ITB-2016-205 Addendum No. 2 dated 8 September 2016

Addendum No.2

ITB-2016-205: Rehabilitation of Magam en-Nabi Musa in Jericho Governorate

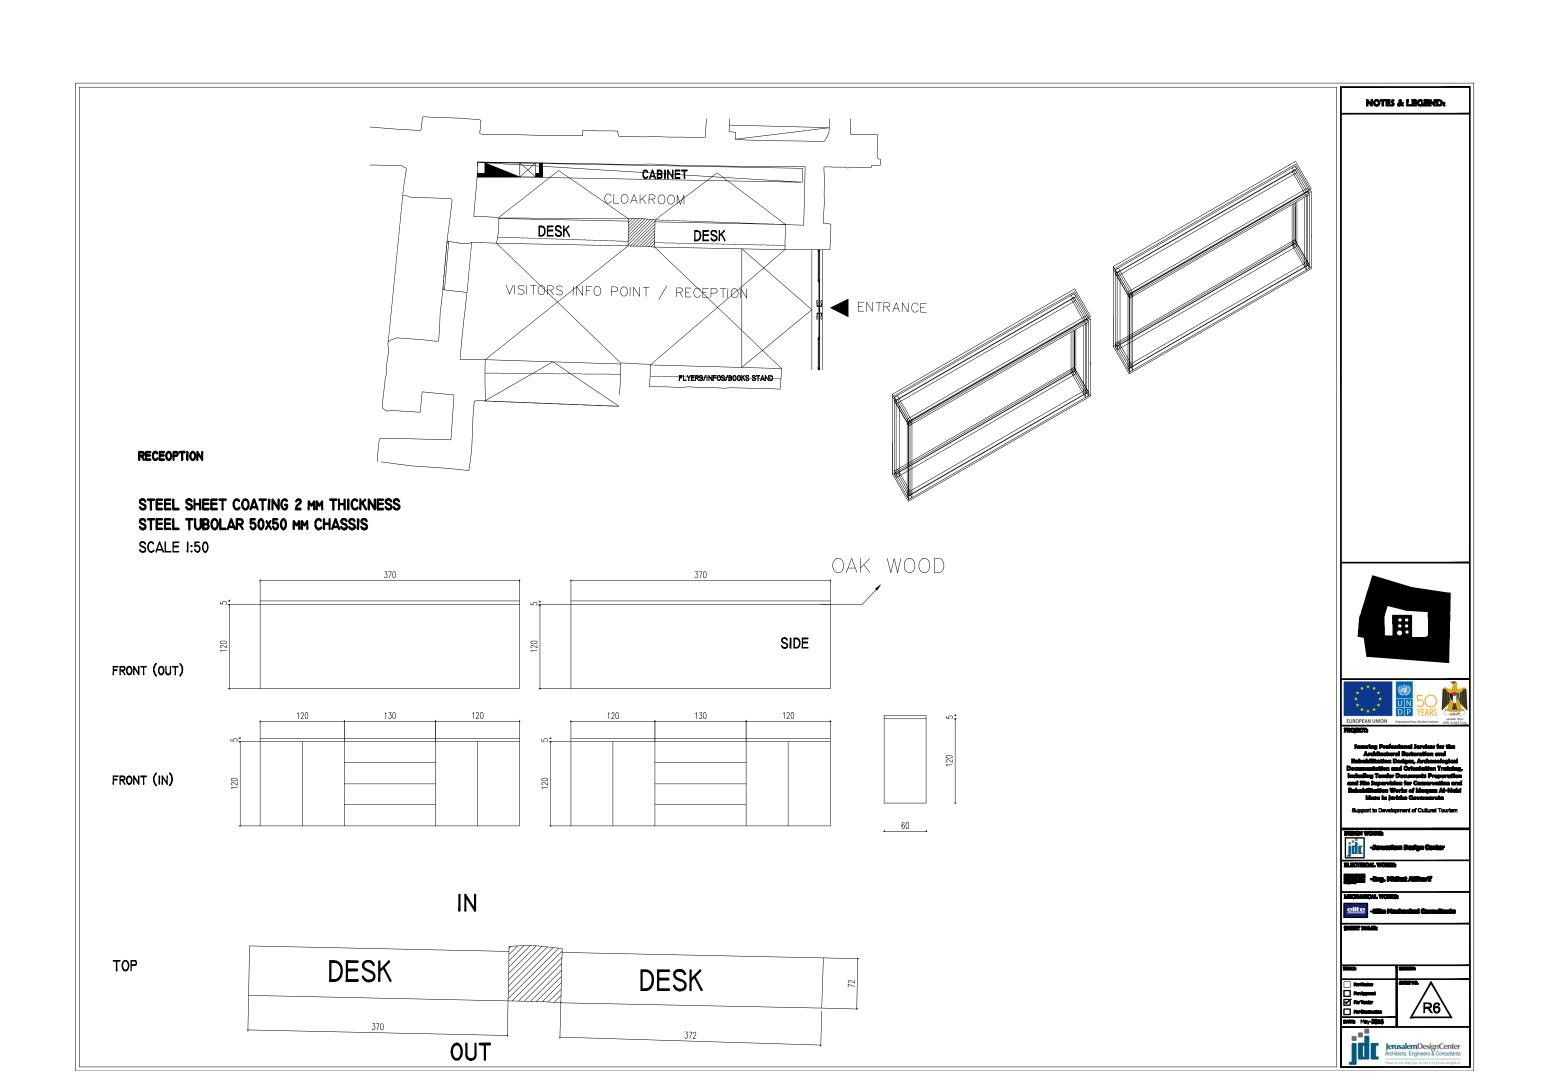
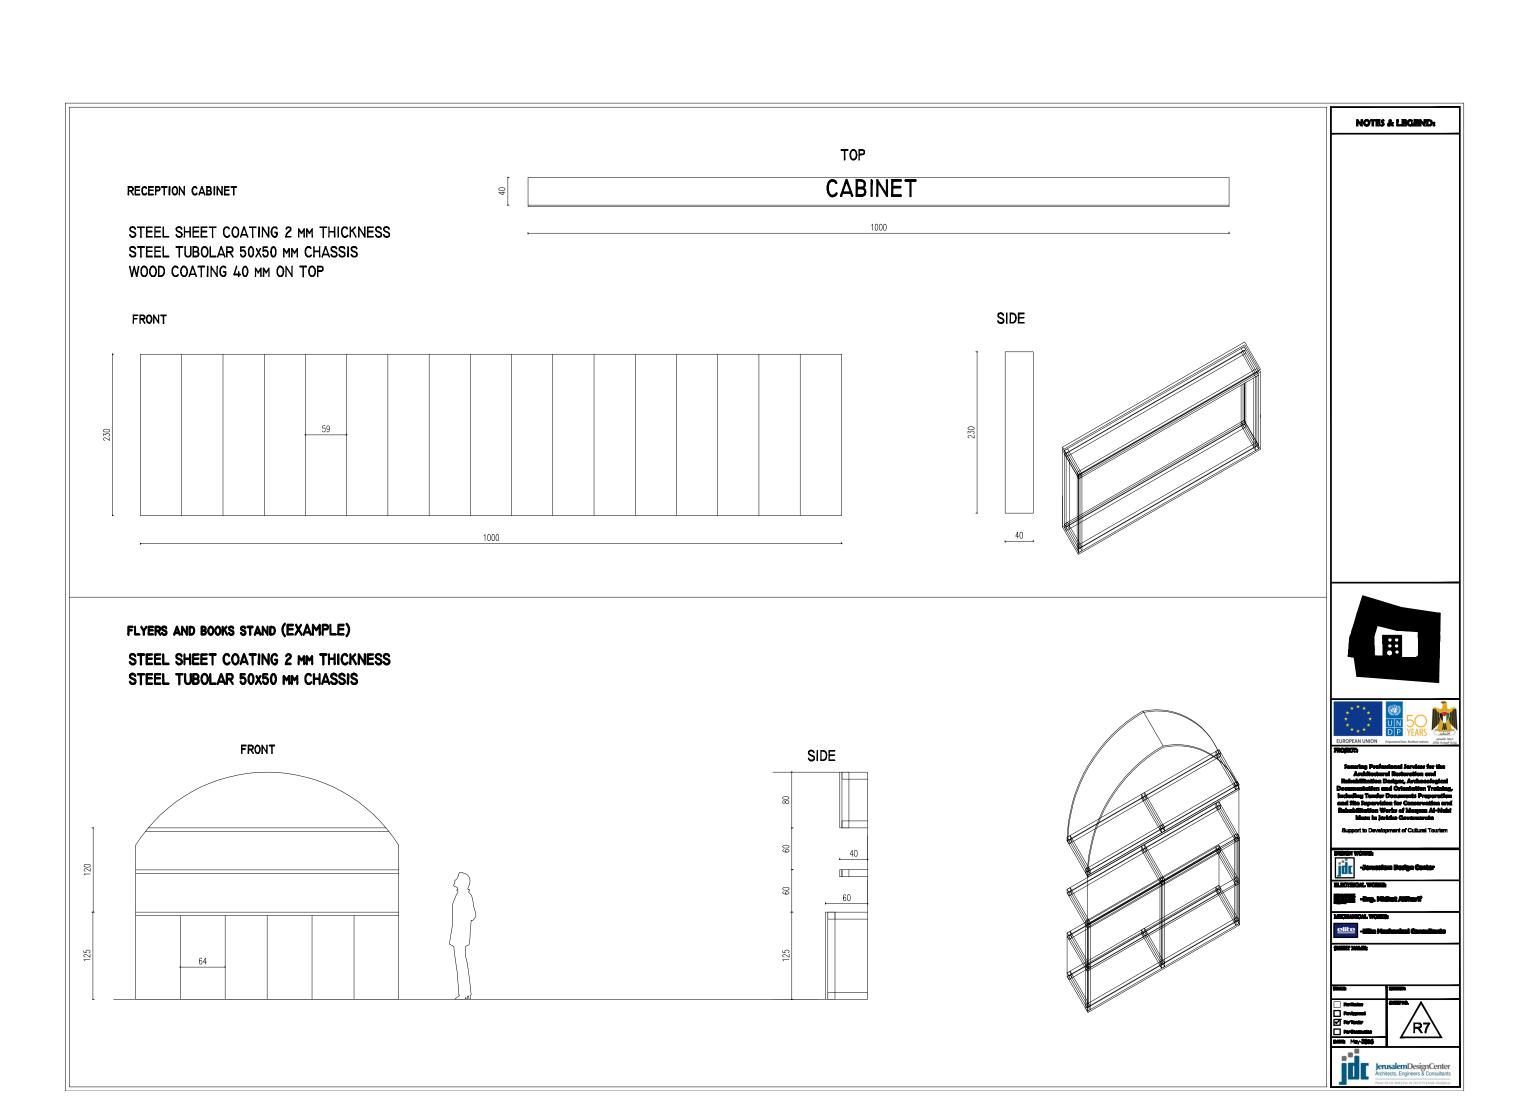
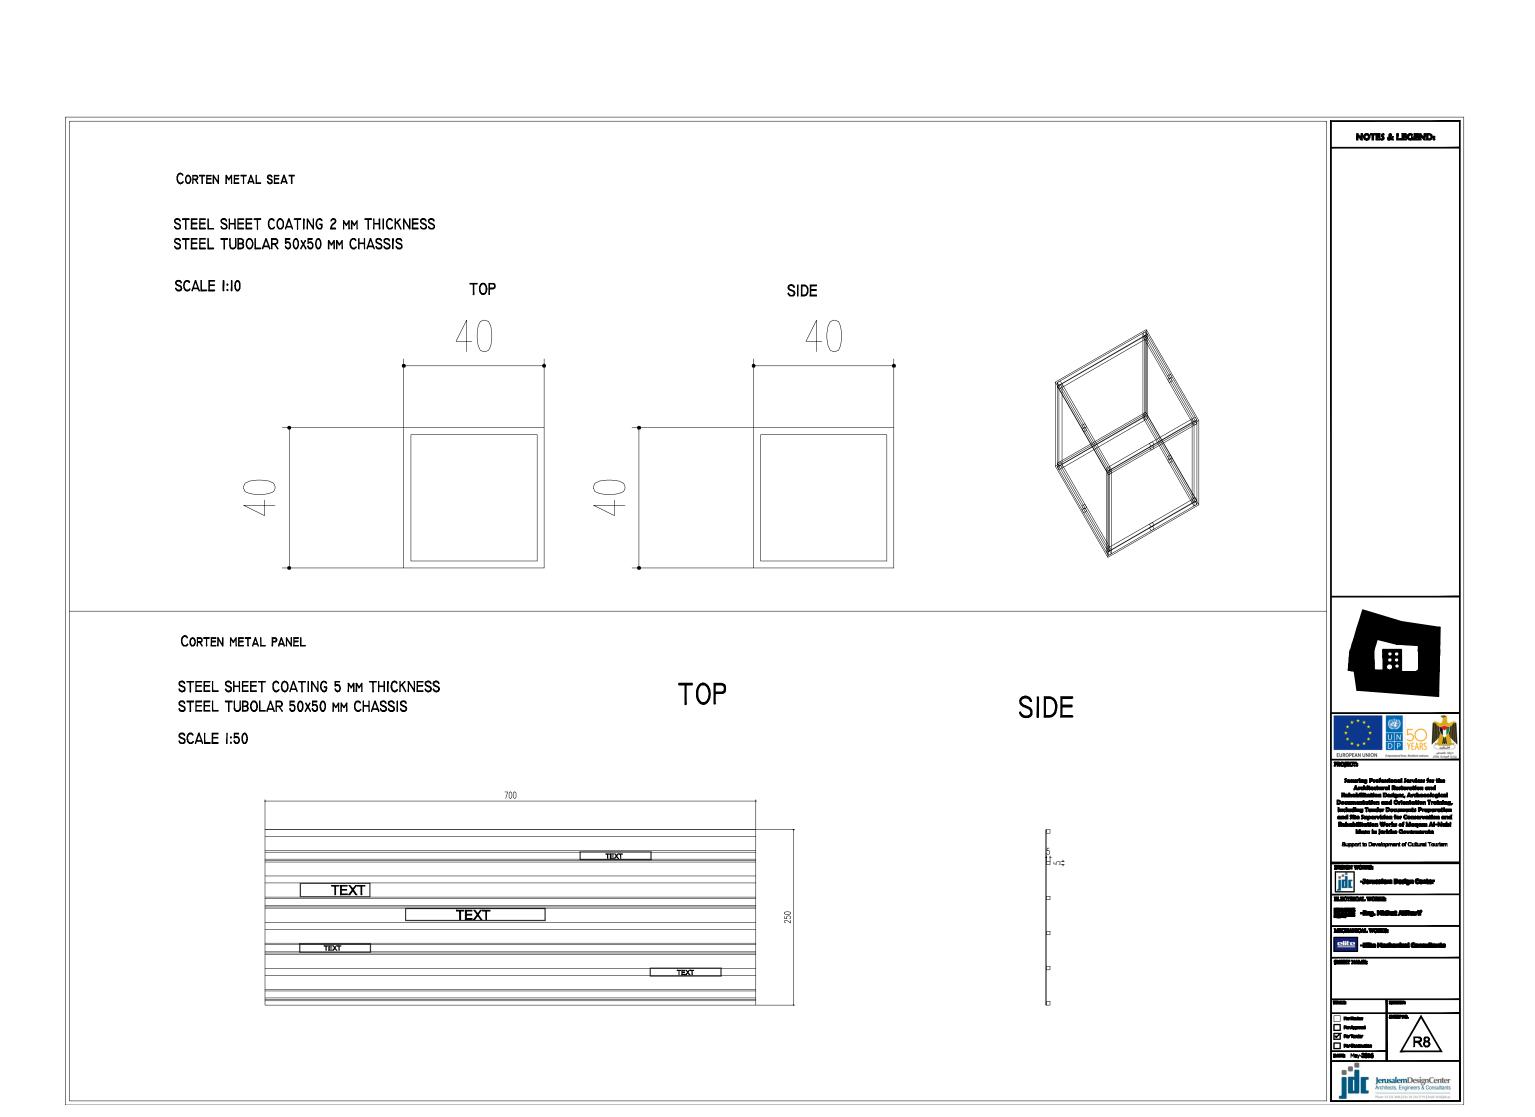
QUESTION No. 3:	Item 11-2 Environmental Center (Indoor spaces), Kindly supply us detailed drawings for each sub items a-k since there are no detailed information in the tender drawings to be used in pricing process.

QUESTION No. 4:	 Item 11-3 Environmental Center (Outdoor spaces); (a) Sub Item a; detailed drawings for the standing panel at the entrance are missing, please supply. (b) Sub Item b; plants pot shown in details No LD01 differ than item description, please clarify and supply us more details. (c) Sub Item d; please supply us more details showing metal and wood

REPLY No. 3:	A + D + F + H, Check Details EC03 Panel Board, EC07 Panel Board B, Check Details EC03 Metal Stand, EC07 Metal Stand C, Check Details EC05, EC06, EC08 Working Table G + I + J + K, All units are in No. instead of MR, Check attached Drawing R8

REPLY No. 4:	sizes including the distance between construction profiles. (d) Sub Item e; please clarify what is meant by M6 (unit) and specify what is the diameter and type of steel rope. (e) Sub Item g, h, & i; please supply us more details showing metal and wood sizes including the distance between construction profiles. (f) Sub Item j; please specify the thickness of 15x15 cm bars and the 5x2 cm bars and supply us a plan showing the distance between bars 5x2 cm. (a) Check attached Drawing R8

(b) Check Details LD01 Typical Landscape Details, EC08, CD19 with Ground Floor Plan(c) Check Details EC05, EC06, EC07, EC08
	 (d) Unit is MR, Hot dip galvanized steel and pre-stretched, Diameter 5mm (e) Check attached Details R8,R9 (f) F. 15x15 bars and 5x2 bars thicknesses are 3.75 MM, distance between
	bars is 30cm
